# Access Compliance Report

### (Curb Ramps)

Intersection ID: 10035551	Main Street: REA_RD	Cross Street: N/A	Location: NE
ADA ID: 7DABE9ABCF4D	Ramp Type: Para	Initial Pass/Fail: Fail	Overall Compliance: No
Severity Score: 13.75			
Codes/Mitigation Info/Possible Solution		Field Measurements/Component Compliance

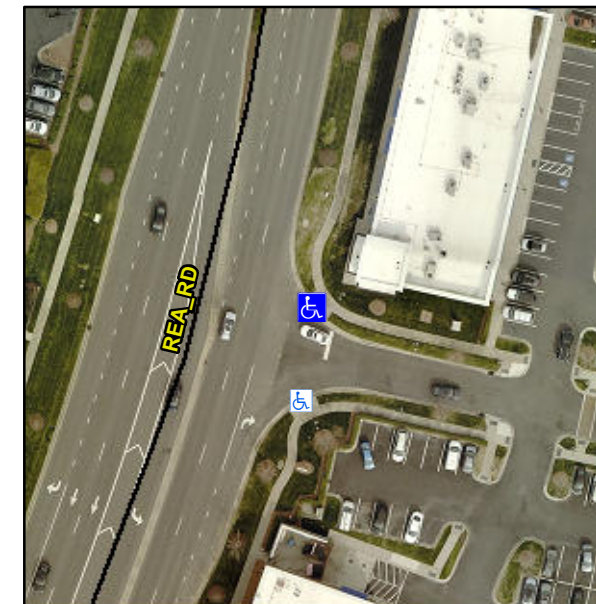
**R304.5.3, R304.3.2**

Compliance	Description	Data	Compliance	Description	Data
N/A	Ramp Length LT (in)	51.0	N/A	Ramp Length RT (in)	44.0
Yes	Ramp Width LT (in)	60.0	Yes	Ramp Width RT (in)	60.0
Yes	Ramp Slope LT (%)	5.2	No	Ramp Slope RT (%)	10.5
No	Ramp XSlope LT (%)	2.1	Yes	Ramp XSlope RT (%)	0.2
N/A	Landing Length (in)	N/A	N/A	DWS Provided?	N/A
N/A	Landing Width (in)	N/A	N/A	DWS Contrast?	N/A
N/A	Landing Slope (%)	N/A	N/A	DWS Length (in)	N/A
N/A	Landing X Slope (%)	N/A	N/A	DWS Full Width?	N/A
N/A	Landing Curb? (Y/N)	N/A	N/A	DWS Offset (in)	N/A
N/A	Shared Landing?	N/A			
N/A	Gutter Ponding?	N/A	N/A	Gutter Slope (%)	N/A
N/A	Gutter Lip Ht (in)	N/A	N/A	Gutter X Slope (%)	N/A
N/A	Painted X Walk1?	No	N/A	Painted X Walk2?	N/A
	X Walk 1 Direction	To SW		X Walk 2 Direction	N/A
N/A	X Walk 1 Width (in)	N/A	N/A	X Walk 2 Width (in)	N/A
	X Walk 1 Slope (%)	2.1		X Walk 2 Slope (%)	N/A
	X Walk 1 X Slope (%)	3.0		X Walk 2 X Slope (%)	N/A
N/A	Ramp inside XWalk1?	N/A	N/A	Ramp inside XWalk2?	N/A

**Remove & Replace Entire Ramp.**
